Re: **Initial Submission Review – Porteos** (Infrastructure CSP)
Application Number: **DA-1903-13**
Case Number(s): **2019-6032-00**

INFRASTRUCTURE CONTEXTUAL SITE PLAN NO.5 AT PORTEOS

INFRASTRUCTURE SITE PLAN
E. 64TH AVENUE PLAN VIEW

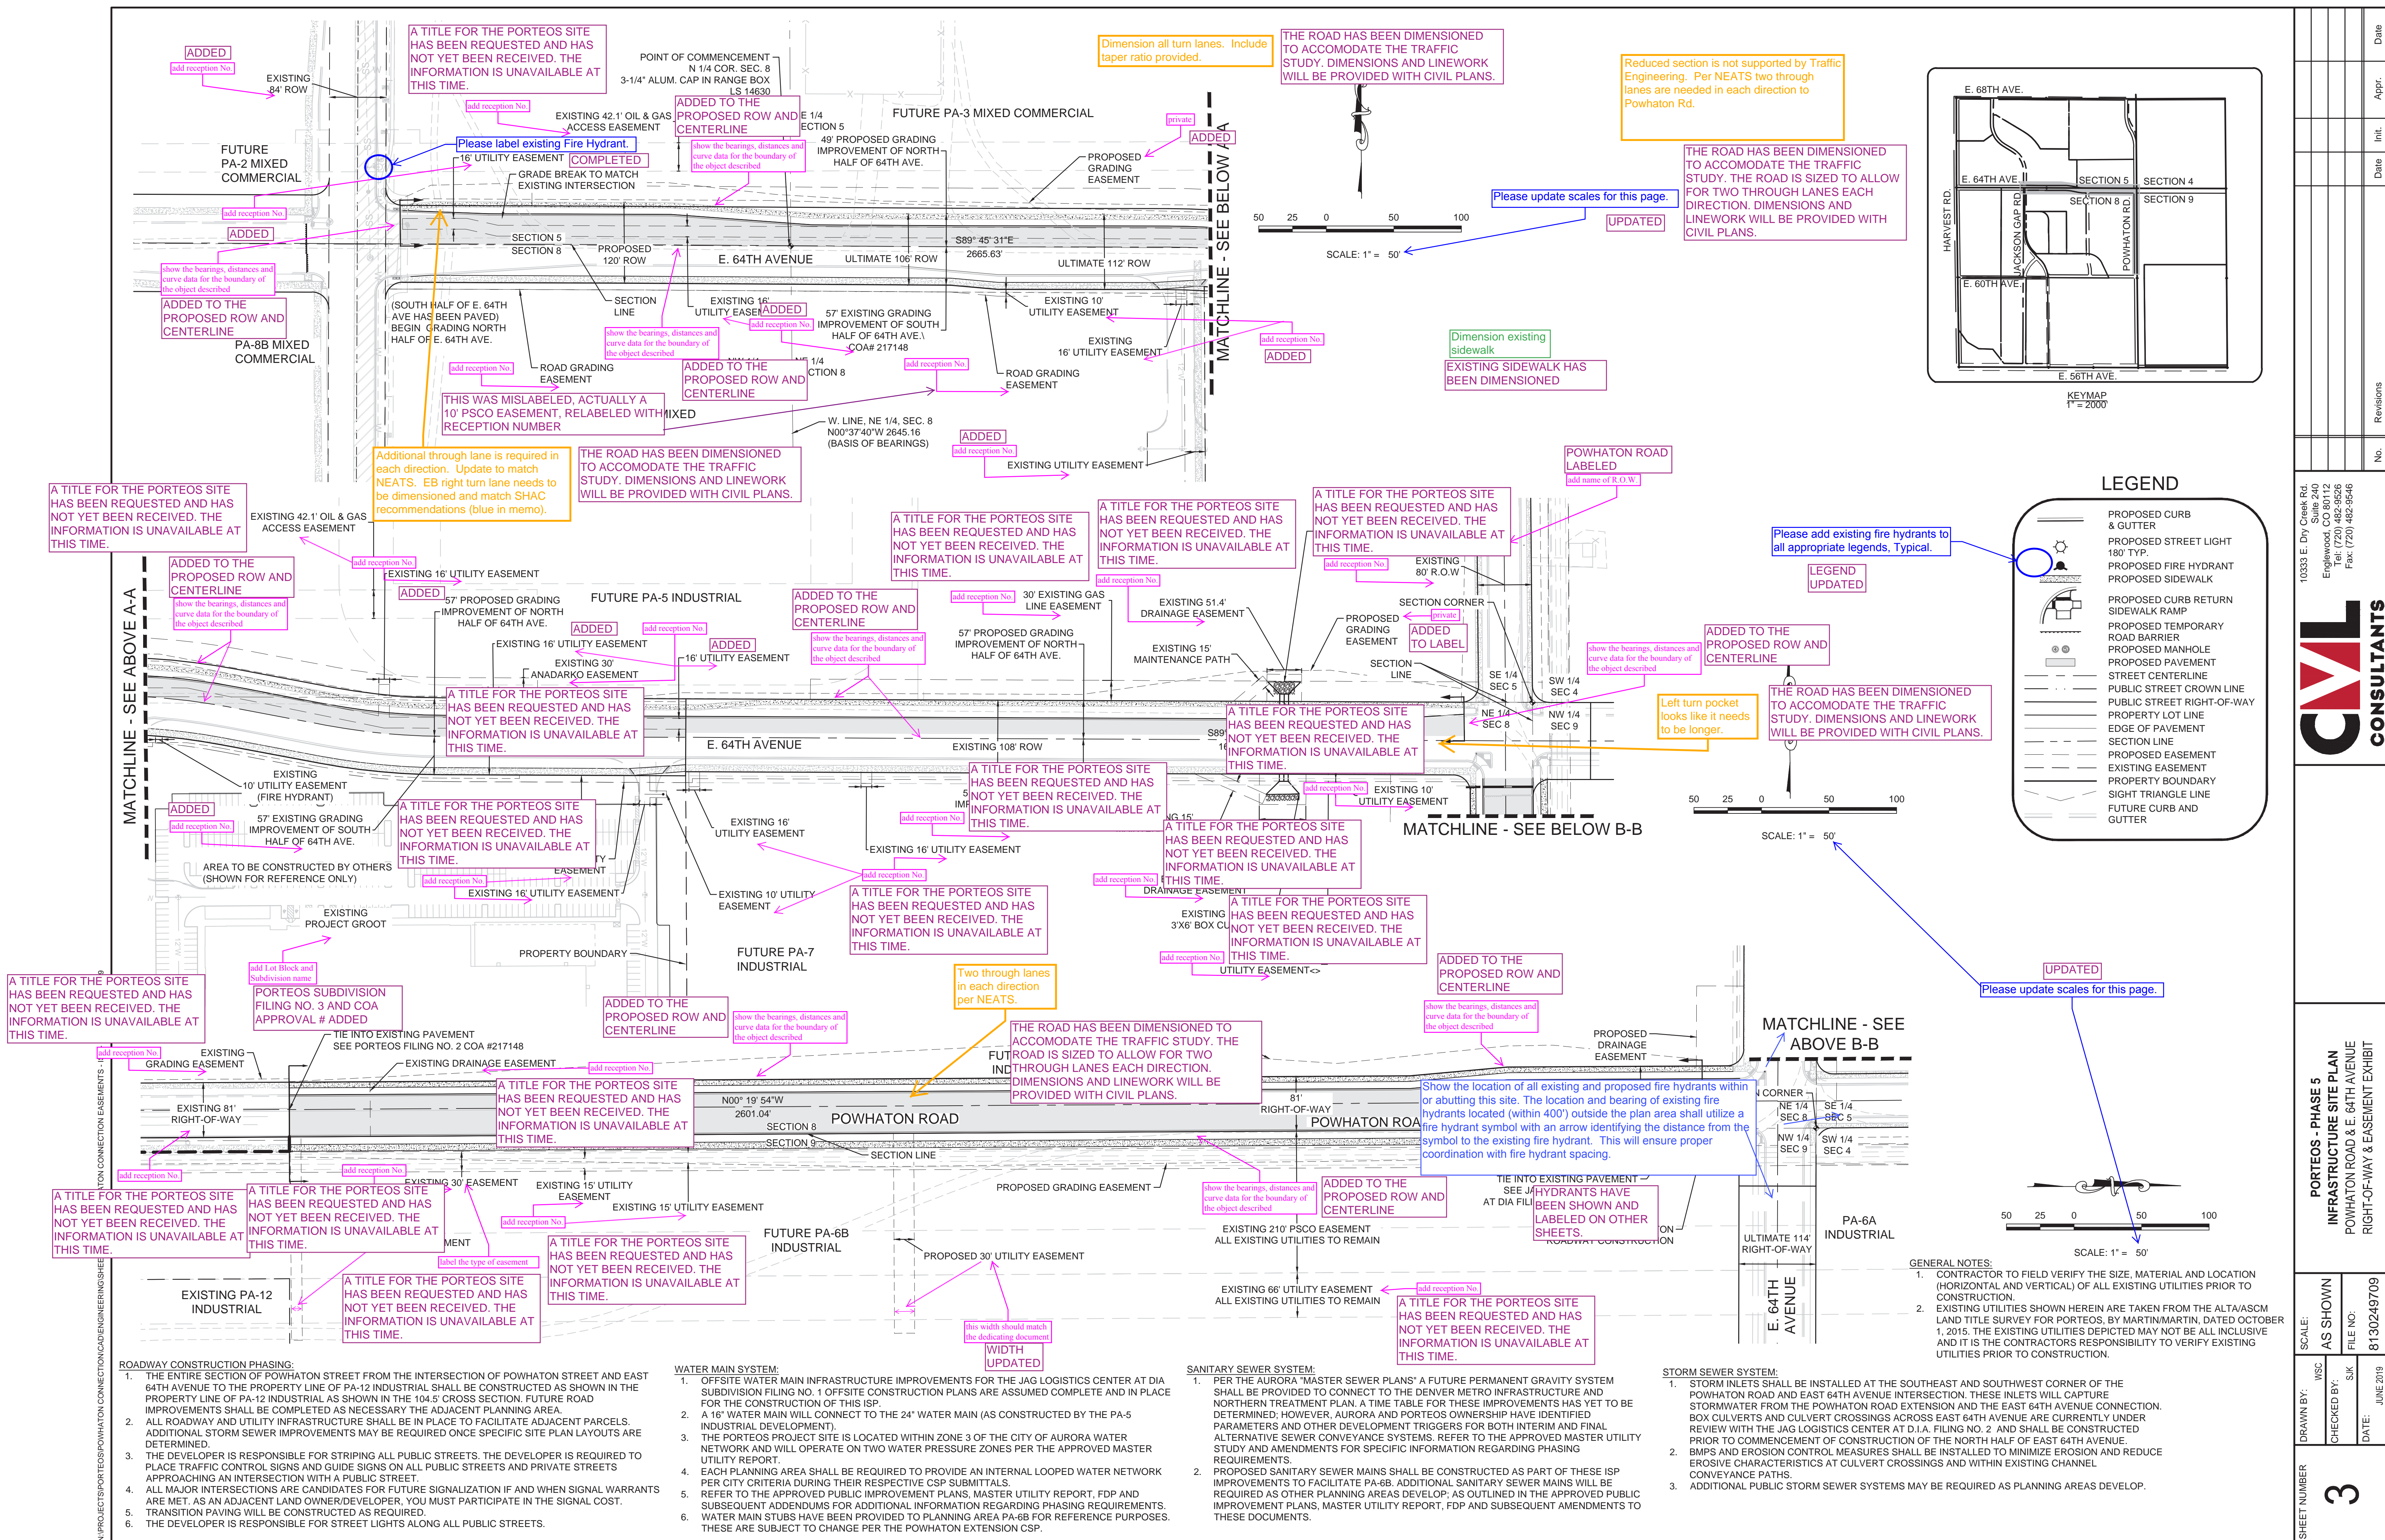
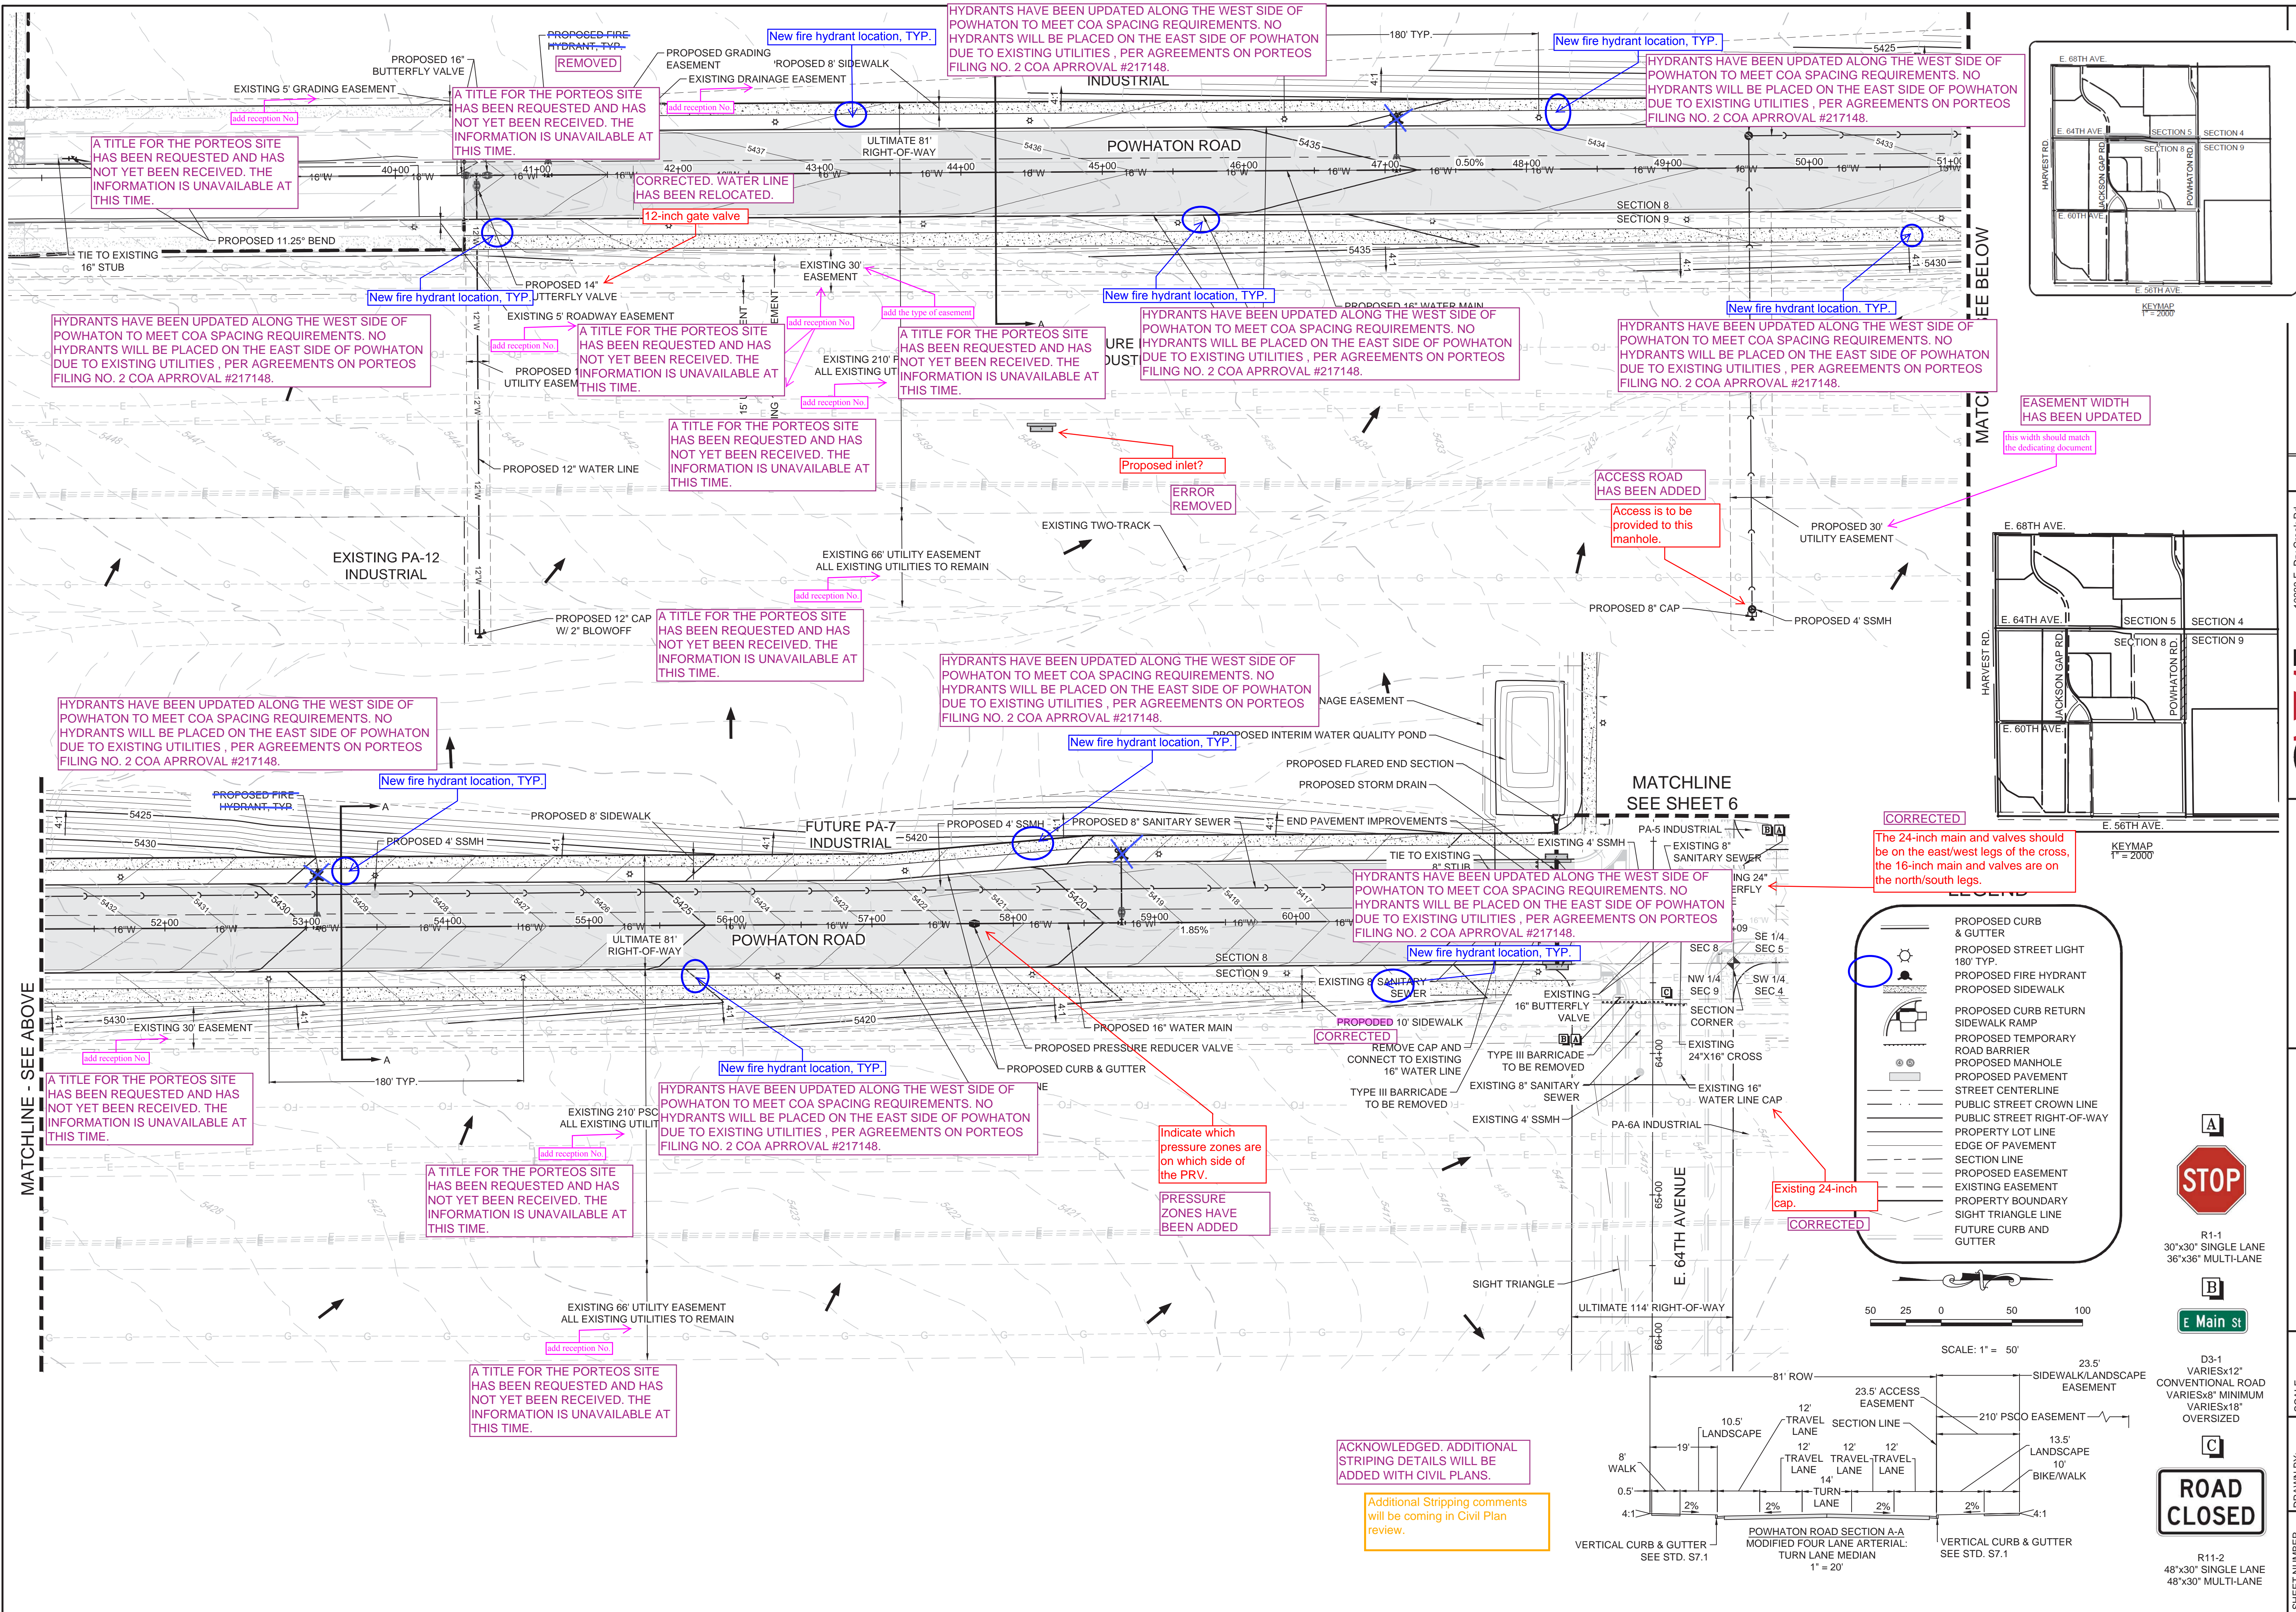
Proposed laneages do not match NEATS. Ensure proposed laneages match NEATS and Traffic Memo auxiliary lane recommendations to CDOT SHAC. Provide dimensions for all auxiliary lanes.

The site plan will not be approved by public works until the preliminary drainage letter/report is approved

Please remove AutoCad SHX text items in the comment section. Please flatten to reduce select-ability of the items.

Response: Laneage now matches traffic study.

Response: Acknowledged.

Response: SHX text has been removed.
